ROGERS RANCH

PRELIMINARY OVERALL AREA DEVELOPMENT PLAN

Re: Rogers Ranch (Amendment)

MDP # 538 B

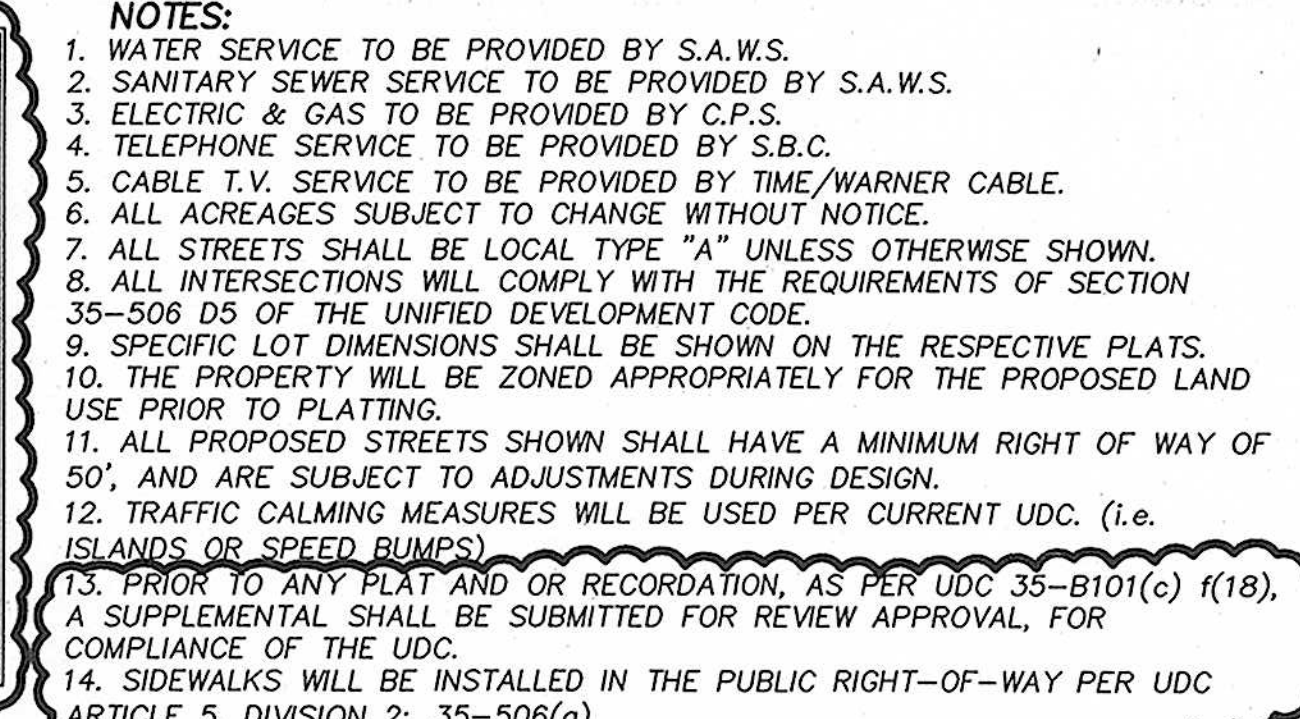
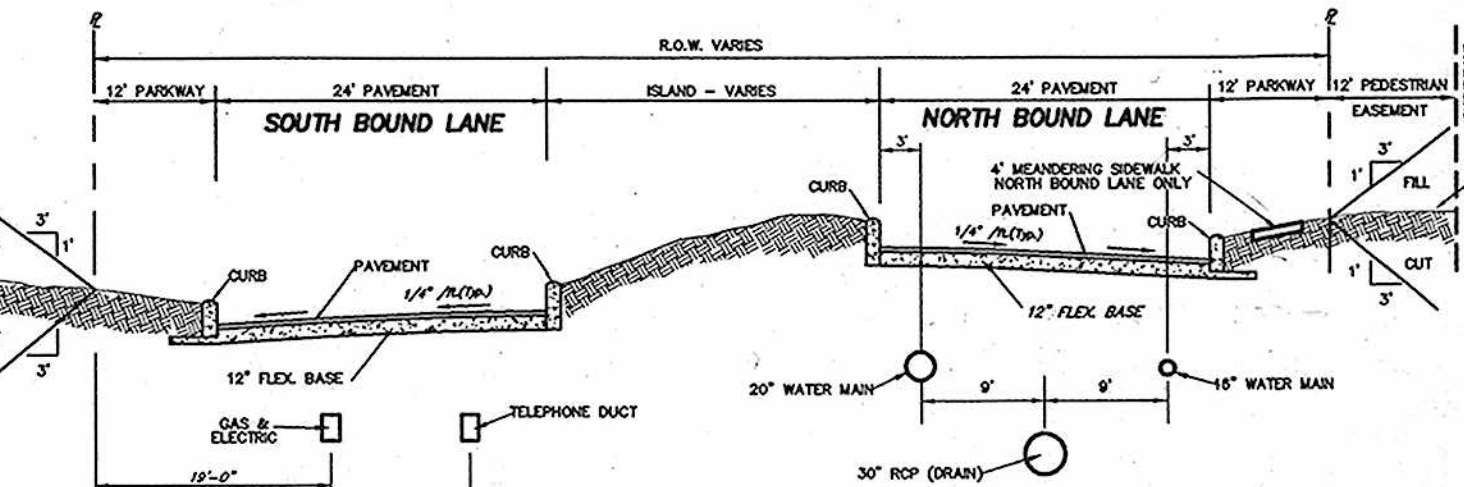
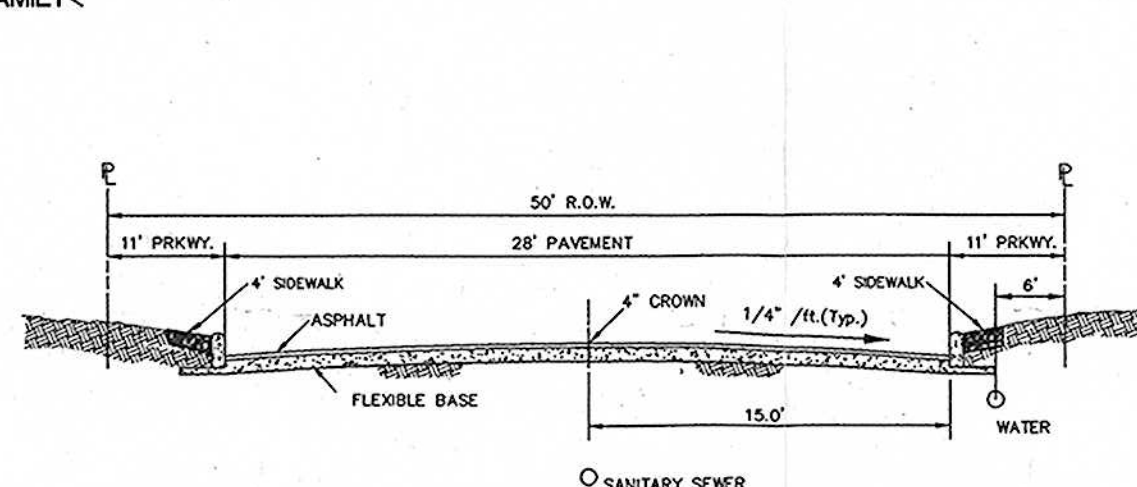
- In consideration of public safety and convenience, excessive grades by reason of topography should be avoided in street layouts and arrangements.
- Any access and R.O.W. issues along state facilities will need to be resolved with the **Texas Department of Transportation (TXDOT)**. For information about these requirements you can contact TXDOT at 615-5814.

shopping center. This development is estimated to generate 80,393 average daily trips, and 7,373 weekday PM peak-hour trips. The approval of Rogers Ranch (Amendment 538 B) MDP, represents only the approval of the collector street shown from 1604 north, turning west and connecting to NW Military Hwy. The original Parsons TIA dated October 2000 no longer is valid due to the abandonment of the development plan, and it's location of major streets. The TIA division understands (as stated in the Memo) that the revised POADP TIA Memo dated August 10, 2005 is only to highlight the differences in proposed development between the Parson's TIA and current plans. No site layouts, specific development plan or locations has been provided for the single-family, multi-family, office building, or shopping center areas in the 1604/NW Military area. It is understood that development plans may change. The TIA division shall require an appropriate TIA submitted for each development as they are proposed and come in for rezoning, platting, and/or building permits. No specific development layout has been provided for the site including turning movements, internal private or public streets, or driveway locations onto 1604, NW Military or the proposed collector. The developer shall be responsible for providing right-turn deceleration lanes as well as left turn lanes, with storage lengths and bay taper as it relates to future development's TIA traffic counts, (Uniform Development Code (UDC) - 35-502 (a)(7), subsection C.

It should be understood that the submitted TIA concurrent with the proposed Rogers Ranch (Amendment 538 B) is a conceptual plan and therefore this document does not represent an approval for the internal street plan. All streets and driveways shall follow UDC 35-506 and the street network shall be planned in order to provide safe and efficient movement of traffic to and from, within and past, the proposed development, while minimizing the impact to non-site trips. UDC 35-506 will be implemented at the time of platting.

Regarding the approval of the collector street, the following requirements and on-site improvements are necessary and shall be provided by the developer, on and before the completion of the Rogers Ranch (Amendment 538 B), at no cost to the City of San Antonio: All access roadways shall provide clear sight distance on all existing and proposed roadways in order to provide adequate obstruction free viewing distances for approaching traffic. All signage, landscaping, and improvements shall be selected and located so as to not block these clear sight distance areas. All commercial driveways for this project shall comply with UDC 35-506, (r) Access and Driveways.
